**St Joseph's Boys National School**

**Planning ref SD21A/0317**

**Response to Condition No 6**

Figure 1 Layout of planter boxes

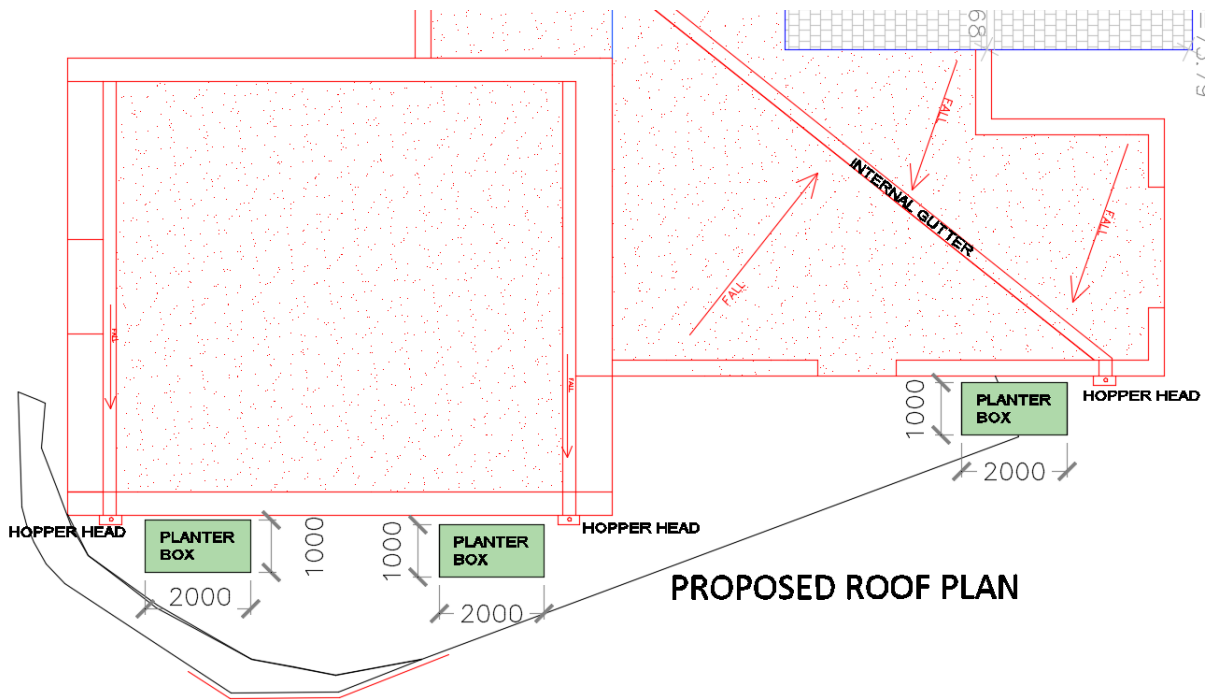
- b) *Submit a report and drawing showing how surface water will be attenuated for proposed development. Surface water can be attenuated by means of SuDS (Sustainable Drainage Systems). The report shall show what surface water attenuation is required in m<sup>3</sup> and what surface water attenuation is provided in m<sup>3</sup>.*

- c) *The applicant shall show in a drawing and report what SuDS features are proposed for the development. Examples of SuDS include and are not limited to Rain Gardens, Green Roofs, Water Butts, Planter boxes, Permeable Paving, Grasscrete.*

- b) See Appendix B for calculation for attenuation required for the new extension. The new roof area is circa 129m<sup>2</sup>. Based on an allowable runoff of 2l/s this would require an attenuation volume of 310litres. This attenuation will be provided by installing three number planter boxes of size 2.0 long by 1.0 wide by 1.0m tall planter boxes with 300mm of pea gravel to base to provide water storage. At a void ratio of 30% this will provide  $3 \times 2.0 \times 1.0 \times 0.3 = 0.54\text{m}^3$ , 540 litres which exceeds the required volume.

The planter boxes will be connected to the rainwater pipes and positioned on site as below figure. The bottom 300mm will be filled with pea gravel. By utilising this method, the runoff water will be used for irrigation of the planter boxes and will also provide filtering of water to remove leaves and debris as well as provide the required attenuation volume.

- c) As noted above planter boxes as per Figure 1 will be provided on the rainwater pipes to the new extension. Drawing 43.211-HP-00-ZZ-DR-S-03002 illustrates the layout.
- d) We can confirm that the design shows the surface water and foul water systems as separate systems and the construction will be monitored to check it is installed in this manner.
- e) Noted, all works will comply with the requirements of the Greater Dublin Regional Code of Practice for Drainage Works.

**43.211-HP-00-ZZ-DR-S-03001 Existing Surface Water Drain**

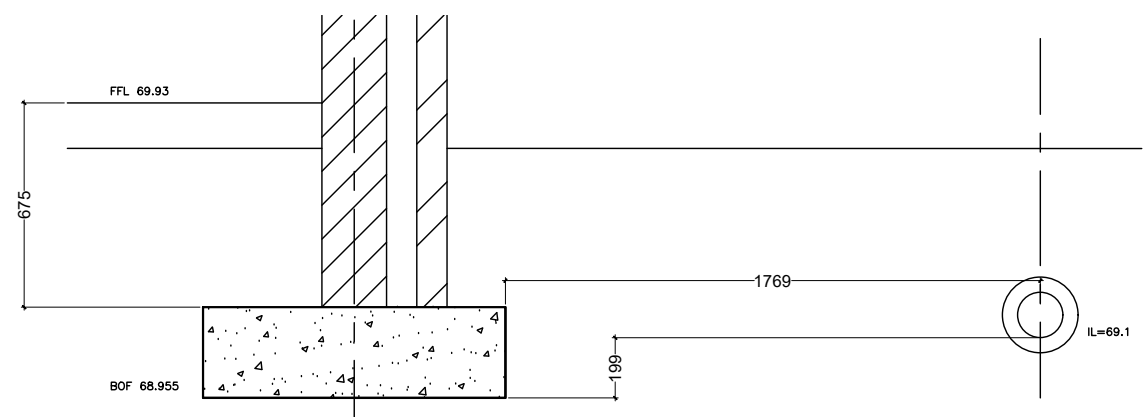
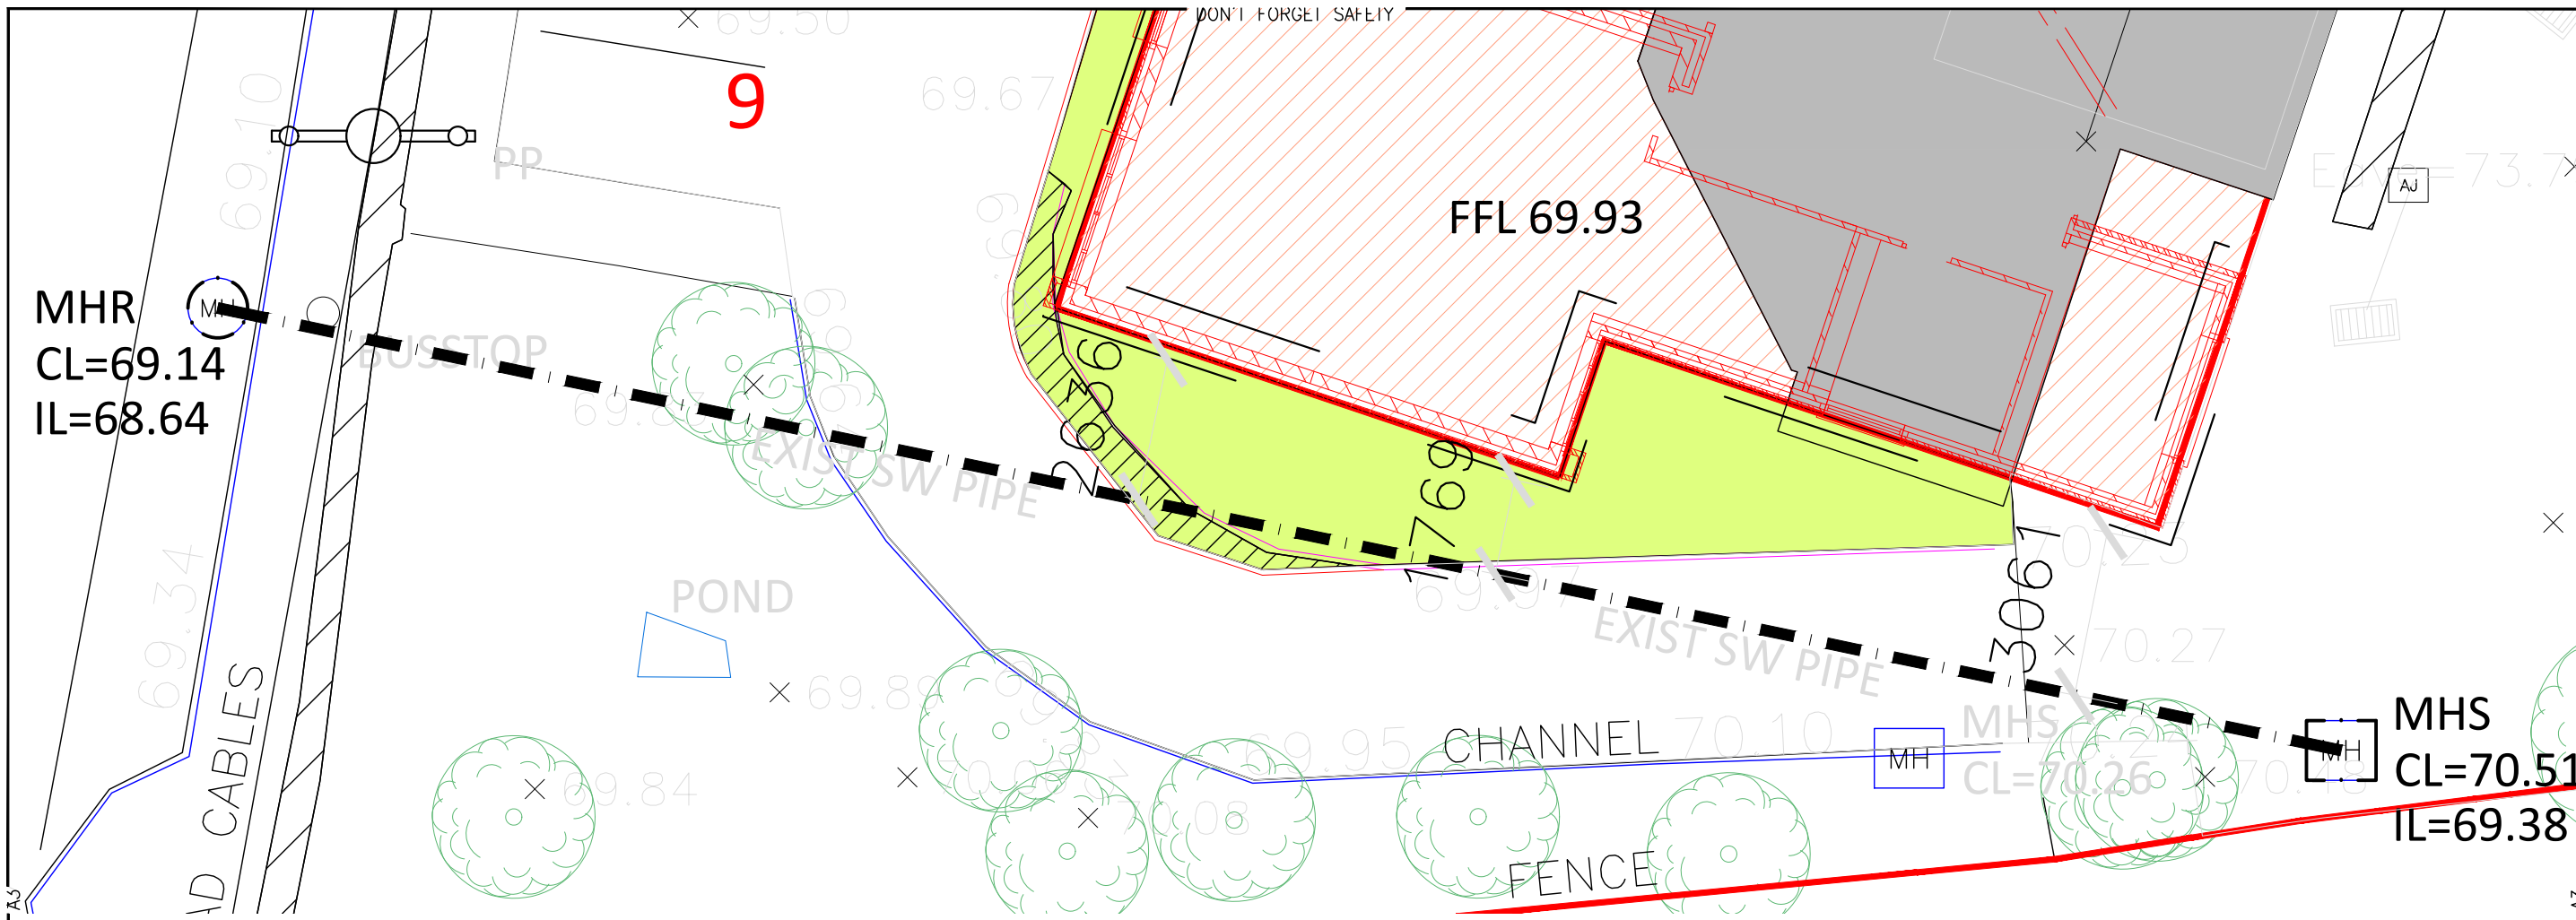
- a) *A drawing in plan and cross-sectional view showing the distance between foundation of proposed development and existing surface water drain south of same. There shall be no loading on existing surface water drain. Provide a report and drawing what access to existing surface water drain will be available to maintain same.*

- a) See appendix A for drawing 43.211-HP-00-ZZ-DR-S-03001 showing the relationship on plan and in section between the existing surface water pipe and the proposed school foundation. As can be seen from the drawing the pipe is sufficiently far away from the school foundation so that, the foundation will not impose and additional pressure on the pipe and that future access of the pipe will not undermine the school foundation. There are concrete and tarmac roadways and access routes that will provide access to the required manholes for any maintenance issues.
